**HISTORIC PRESERVATION REVIEW BOARD
STAFF REPORT AND RECOMMENDATION**

Landmark/District:	Anacostia Historic District	(x) Consent
Address:	1644 U Street SE	
Meeting Date:	January 26, 2017	(x) Addition
Case Number:	17-141	
Staff Reviewer:	Tim Dennée	(x) Permit

The applicants, property owners Sheryl and Leonard Bennett, request the Board's review of a permit application to construct a two-story addition with a walk-out basement, to alter a front basement entrance and the front porch, and to replace the windows. The two-story semi-detached brick house was constructed in 1912.

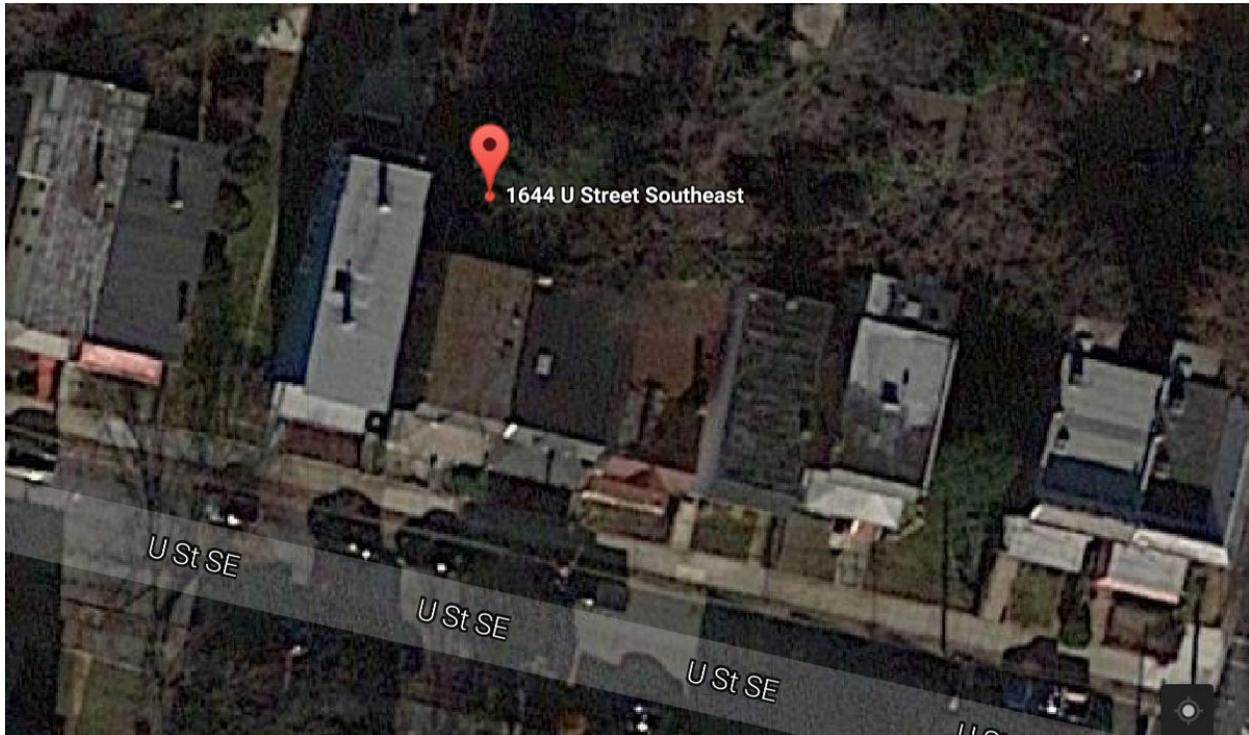
Proposed for replacement are the porch posts and balustrade. Mid-twentieth-century steel supports would be replaced by full-height Tuscan columns, similar to what homes of this type and period would have had originally. A close examination of the porch shows that the central brick pier supporting the porch slab is not below the middle porch support. The replacement column supporting the middle of the porch span almost certainly should be right over that pier, as that was probably the original condition for structural reasons and because the front steps would then be centered between that column and the one on the east corner.

Related to the location of the pier and column is the issue of the location and size of the porch apron, now openwork concrete block, but proposed to be replaced by period-appropriate framed wood lattice. The lattice should sit between, and not over, the piers; the elevation seems to use it to obscure the central pier. The frame for each panel should be specified as of nominal four-inch-wide lumber, which is typical.

The porch balustrade is not quite right yet, in that it should be wood, rather than composite, and that is too open and spindly. On a house of this style and dating to the 1910s, the balusters would be closely spaced and sit on a beveled bottom rail and beneath a proper grip rail. Probably no more than a block, rather than an intermediate post, is necessary to keep the whole from sagging at center span. On historic homes, balustrades usually vary in height between about 28 and 32 inches. Although a taller rail is called for by code, a shorter one would be better proportioned to the space beneath the porch roof and is allowable as a replacement on a historic house. A section detail of the replacement balustrade should appear in the final permit application drawings.

- 1. the fiber-cement siding of the addition not exceed six-inch exposure;*
- 2. the center porch column be situated over the center pier;*

3. *the porch balustrade be detailed like a traditional balustrade;*
4. *the porch steps be detailed;*
5. *the porch apron lattice be framed by 1x4s, with the panels set between the piers;*
6. *the applicant explore alternative approaches to the basement steps, so that they not extend so far forward of the porch if feasible; and*
7. *there be no new or replacement meters on the front or in front of the house.*
